Nomad SERVICE BULLETIN

PLACARDS ON REAR BAGGAGE DOOR

Figure 2

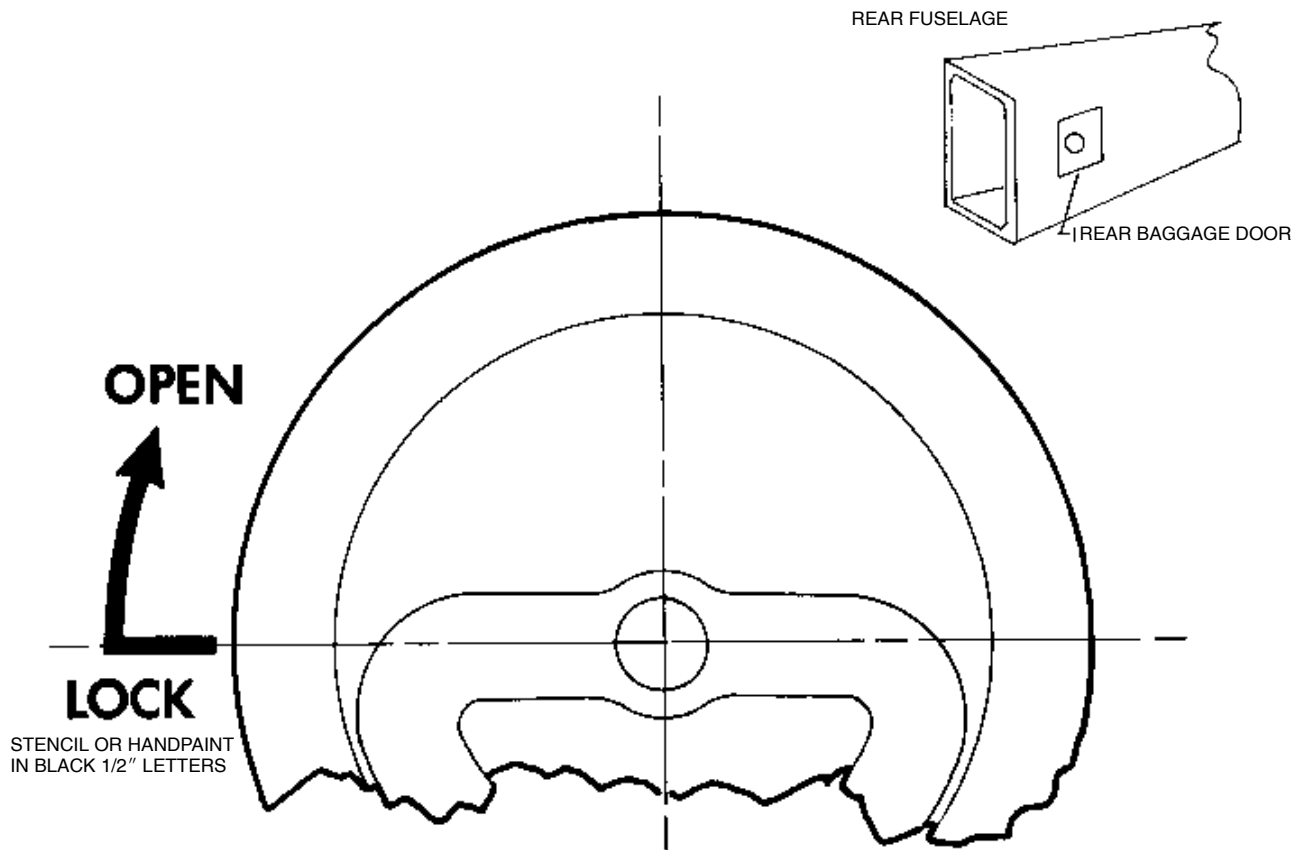
(2) With door shut, locking position of handle is clearly shown.

Paint or stencil placards on inside and outside of rear baggage door as detailed in Fig 1 and 2 of this bulletin.
